UNITED STATES PATENT AND TRADEMARK OFFICE

APPLICATION NO.	FILING DATE	FIRST NAMED INVENTOR	ATTORNEY DOCKET NO.	CONFIRMATION NO.
10/814,020	03/31/2004	Jiann Bang Liou	14334 B	5519

Office Action Summary	Application No.		Applicant(s)	
	10/814,020		LIOU, JIANN BANG	
	Examiner		Art Unit	
	Tam Nguyen		3764

DETAILED ACTION

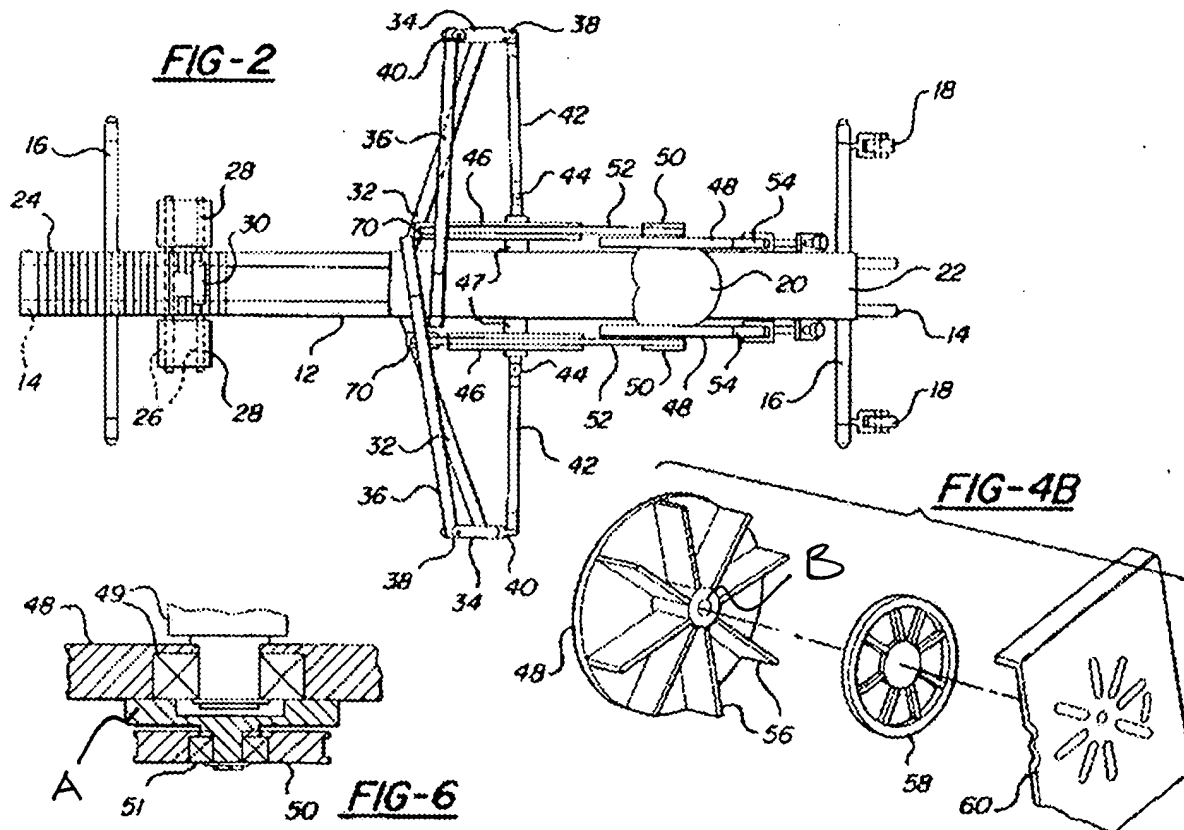
2. As to claim 1, Pape discloses an exerciser comprising a base (12), a rotating wheel (A), a rotary member (46) rotatably supported on the base and coupled to the rotating wheel to allow the rotary member to rotate the rotating wheel, a fan device/flywheel (48,56) attached onto the rotating wheel and rotated in concert with the rotating wheel to generate cooling air. The fan device includes a plate (48) secured to the rotating wheel and the plate has an opening (B) formed therein. The fan device also includes a plurality of fan blades (56) that extend radially and outwardly from an outer peripheral portion of the plate, and the fan blades are spaced away from the opening of the plate. Each of the fan blades includes a side segment that is laterally extended out

of the plate (see Figs. 2, 4B & 6 below).

Pape does not disclose that the plate includes a peripheral flange extended laterally from one side thereof to engage the rotating wheel (A) to firmly attach the fan device onto the rotating wheel. Lay discloses a flywheel (10) having a peripheral flange (C) extended laterally from one side thereof to firmly engage a rotating member (21) (see Fig. 4 below). At the time of the invention, it would have been obvious to a person of ordinary skill in the art to combine Pape's fan device/flywheel with Lay's peripheral flange to provide a strengthened connection between Pape's fan device/flywheel (48) and Pape's rotating wheel (A).

FIG. 4

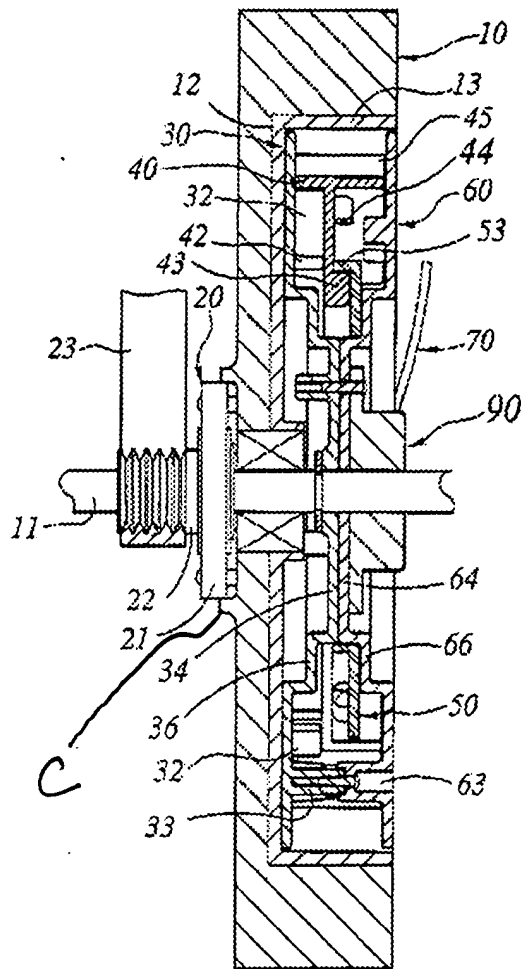
3. As to claim 6, Pape and Lay disclose a modified exerciser as described above. Pape further discloses that a side segment of the fan blades are spaced away from the opening of the plate (see Fig. 4B above). Pape does not disclose that the side segments includes an inclined surface. Huang discloses an exercise device having a
